Access Compliance Report

Public Rights-of-Way

(Curb Ramps)

Intersection ID: N/A	Main Street: TRYON_ST	Cross Street: WOODLAWN_RD	Location: SW
ADA ID: F1FCC462C75F	Ramp Type: Perp	Initial Pass/Fail: Fail	Overall Compliance: No
		Severity Score: 12.5

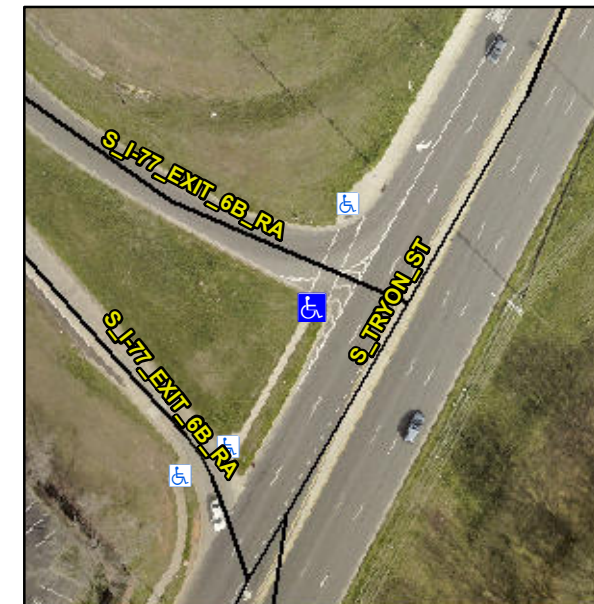
R304.2.2

Compliance	Description	Data	Compliance	Description	Data
N/A	Ramp Length (in)	114.0	No	Ramp Slope (%)	9.3
Yes	Ramp Width (in)	72.0	Yes	Ramp XSlope (%)	0.6
N/A	Flare Type LT	N/A	N/A	Flare Type RT	N/A
N/A	Flare Slope LT (%)	N/A	N/A	Flare Slope RT (%)	N/A
N/A	Flare Traversable LT?	N/A	N/A	Flare Traversable RT?	N/A
N/A	Landing Length (in)	N/A	N/A	DWS Provided?	N/A
N/A	Landing Width (in)	N/A	N/A	DWS Contrast?	N/A
N/A	Landing Slope (%)	N/A	N/A	DWS Length (in)	N/A
N/A	Landing X Slope (%)	N/A	N/A	DWS Full Width?	N/A
N/A	Landing Curb? (Y/N)	N/A	N/A	DWS Offset (in)	N/A
N/A	Shared Landing?	N/A			
N/A	Gutter Ponding?	N/A	N/A	Gutter Slope (%)	N/A
N/A	Gutter Lip Ht (in)	N/A	N/A	Gutter X Slope (%)	N/A
N/A	Painted X Walk1?	Yes	N/A	Painted X Walk2?	N/A
	X Walk 1 Direction	To NE		X Walk 2 Direction	N/A
N/A	X Walk 1 Width (in)	108.0	N/A	X Walk 2 Width (in)	N/A
	X Walk 1 Slope (%)	0.1		X Walk 2 Slope (%)	N/A
	X Walk 1 X Slope (%)	1.7		X Walk 2 X Slope (%)	N/A

Remove & Replace Entire Ramp.
